Reference	SSM72516
Models	XF / X260
Title	X260 XF Boot spring bracket detaching
Category	Body
Last modified	18-Aug-2016 00:00:00
Symptom	111000 Body Panel(s)/Unibody
Attachments	1BIW Spring bracket SSM 2 (1).pdf (1BIW Spring bracket SSM 2 (1).pdf) Swan neck brackets - X260.pdf (Swan neck brackets - X260.pdf)

X260 Boot spring detaching from Body In White bracket and / or spigot bracket

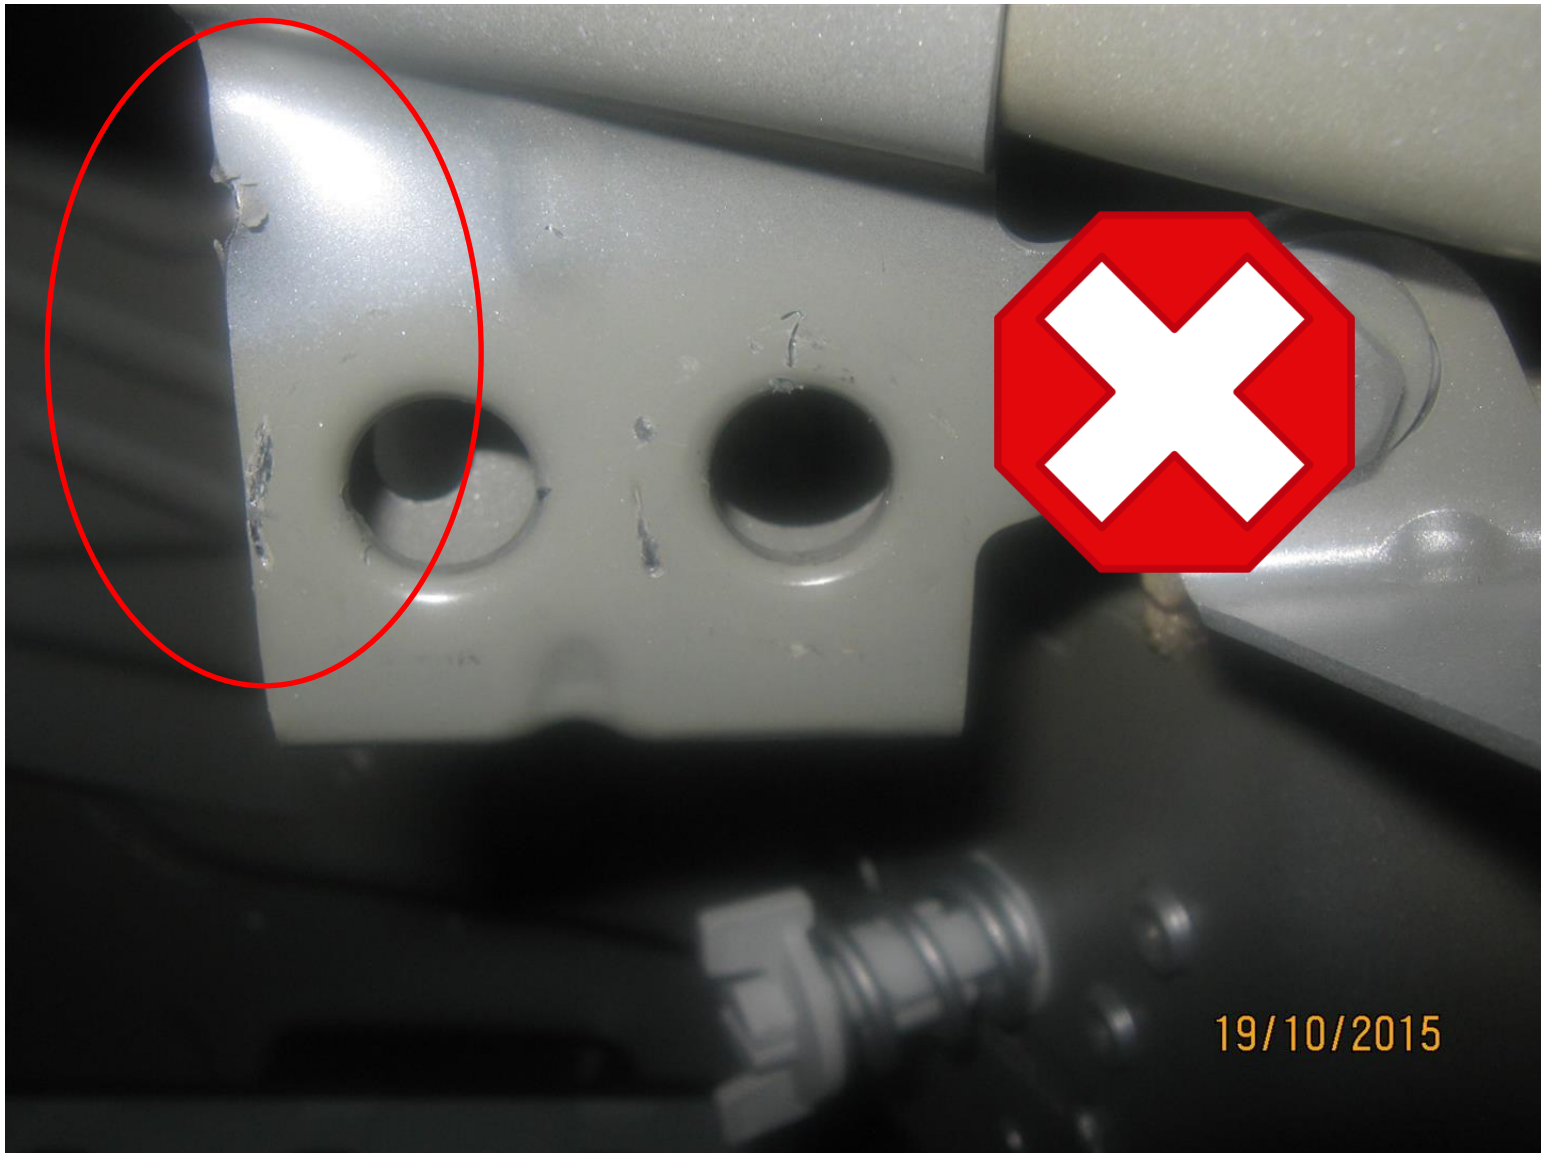
Cause:

Tolerance between fulcrum points on components

If you have a X260 where the boot spring has detached, please order replacement assistance springs and spigot / ball fixing brackets located on the swan neck assemblies and replace both sides regardless of which has failed. For clarity regarding what the spigot / ball fixing brackets are, please see the PDF attachment named 'swan neck brackets', which shows images of them and where they are located. They are listed in the catalogue as follows - 'Mounting bracket - Conventional tailgate - Trunk lid hinge - LH T2H19924 & RH T2H19923'. Both must be changed, regardless which side spring has failed.

In addition, please check the integrity and condition of the Body In White bracket on both sides for any damage and re-work / rectify to bring them to the acceptable condition, particularly the profiling and alignment, as shown on the attachment - before installing new components.
